FAIRFAX COUNTY, VIRGINIA

MEMORANDUM

SUBJECT: Staff Analysis of Conceptual Plan Amendment CPA 86-C-121-8:
Oracle Corporation

Title of CPA: Oracle, Reston, Section 95-2
Prepared by: Davis, Carter, Scott, Ltd.
Dates: February 3, 1999, revised April 22, 1999

DRAWING TITLE
PERSPECTIVES

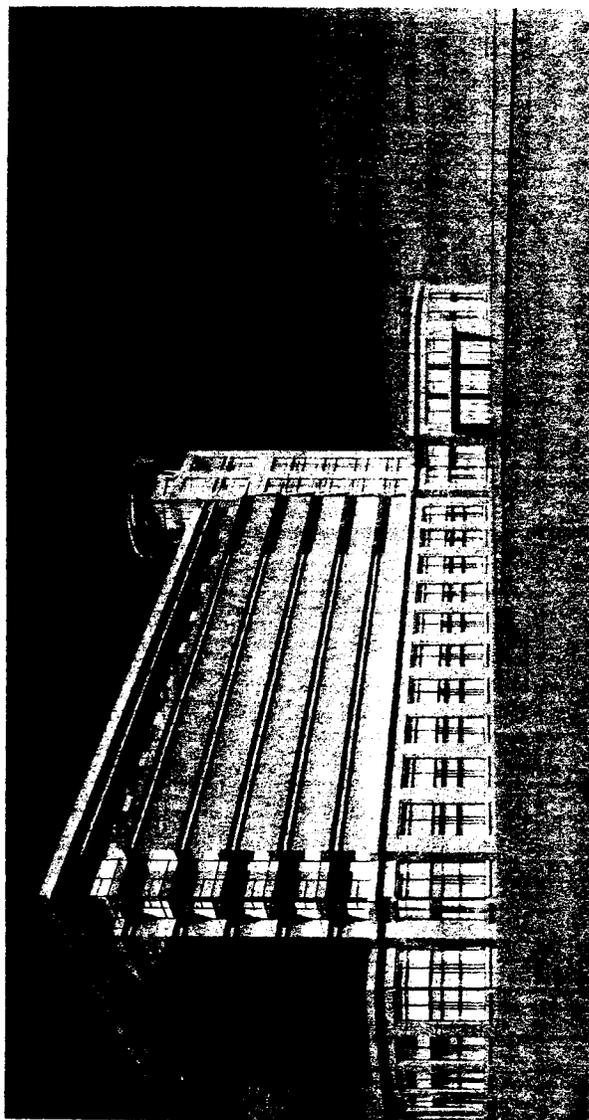
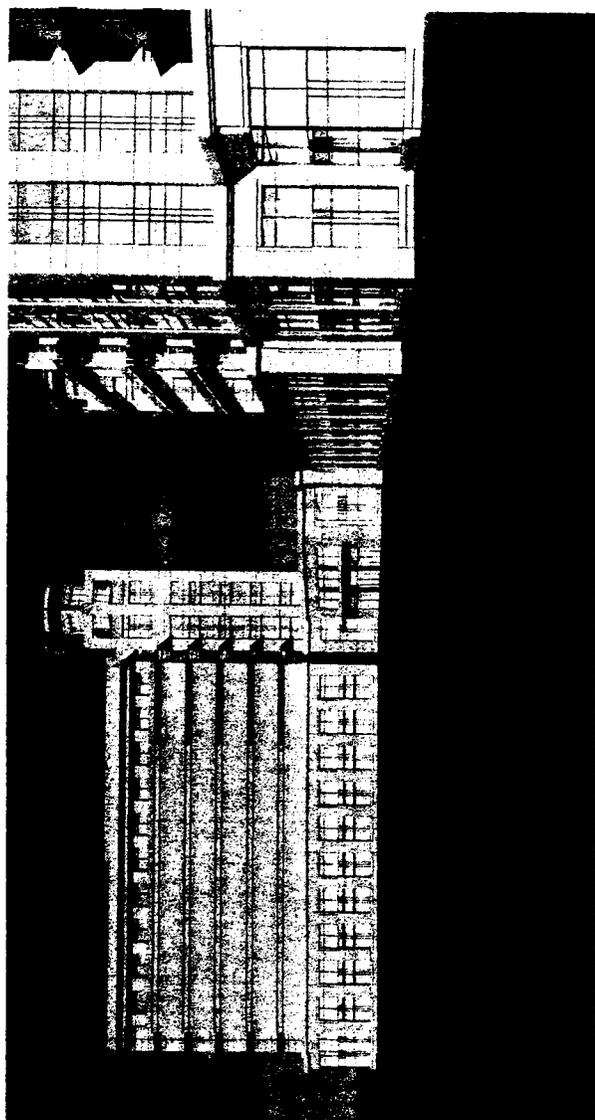
The applicant has resubmitted the approved CP, which consists of nine (9) sheets. Sheet 1 has been revised to reflect the increase in building height for the Phase II building from six to eight stories. Sheet 2 reflects the revised Plan Notes and changes to the Phase II illustrative which reflects a temporary surface parking area in the location of the future Phase IV building to accommodate the surface parking being displaced as a result of construction of the Phase II building. All other aspects of the approved Concept Plan, including the total gross floor area for the site; the number, layout and height of the remaining office buildings and parking structures; pedestrian circulation and landscaping and plaza features remain unchanged.

DRAWING TITLE
LANDSCAPE PLAN

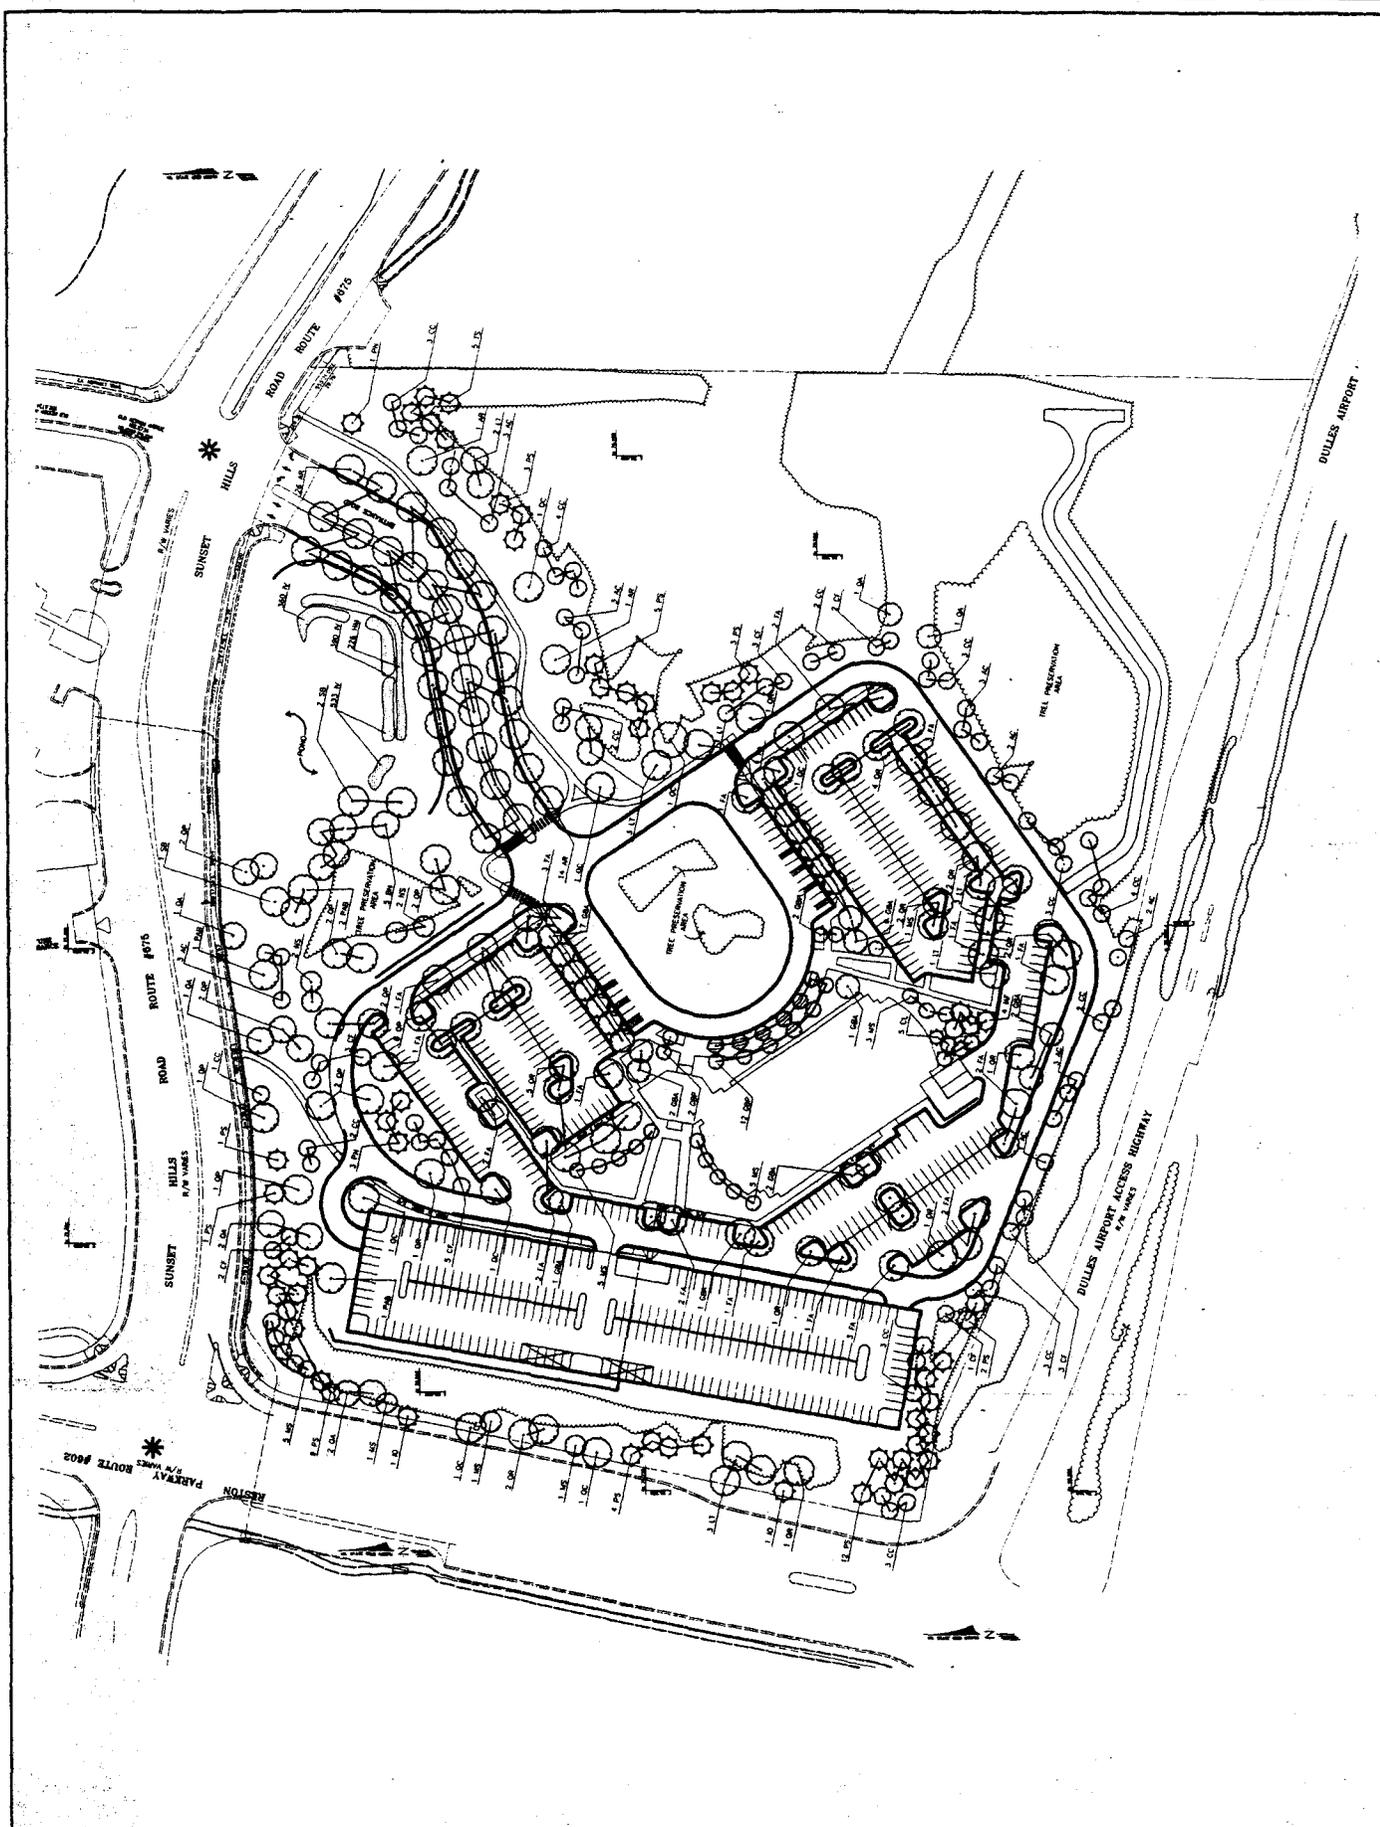
The Urban Forester has noted that with the construction of the Phase II building the existing surface parking lot will be relocated to the area designated for the future Phase IV building. The Phase IV area is currently wooded and contains a number of trees which were included in an inventory of significant trees on the Oracle site. The Urban Forester has noted that several of these trees may be impacted with the construction of the relocated surface lot and has requested that the applicant locate these trees on the Preliminary Site Plan 9523-PSP-02-1 that has been filed concurrently with the Conceptual Plan Amendment and explore the potential for tree preservation with the design of this surface lot. The Urban Forester believes that with minor modifications to the design of the parking lot, some of these trees could be preserved through future phases of the project, especially along the slope adjacent to the entrance road. Staff has forwarded this recommendation to the applicant. It would be desirable for the applicant to commit through a note on the CP that additional tree preservation opportunities will be pursued in consultation with the Urban Forester in the area of the Phase IV temporary surface parking. The applicant has not addressed this issue.

- 11A. As part of the Phase II construction, the Applicant shall retain the services of a certified arborist to evaluate the existing buffer along Reston Parkway and provide recommendations for additional, supplemental landscaping along Reston Parkway. The certified arborist shall identify any trees planted and/or transplanted to this buffer area during the Phase I construction that have not survived or have declined severely and are not anticipated to survive. Those trees identified shall be replaced during the Phase II construction with trees having a minimum 2 to 2.5 inch caliper. In addition, the certified arborist shall identify gaps in the existing landscaping, which shall be supplemented with additional trees and which may include evergreen plantings that may include trees transplanted from areas to be disturbed as part of the Phase II construction, subject to confirmation of the location of utility lines and easements. The Applicant shall incorporate the recommendations of the certified arborist into a revised Landscape Plan for the Reston Parkway frontage to be submitted for review and approval by the Urban Forestry Branch of DPWES concurrent with the second submission of the Phase II site plan. The Applicant shall provide a copy of this landscape plan to the Hunter Mill District Planning Commissioner for review and comment.
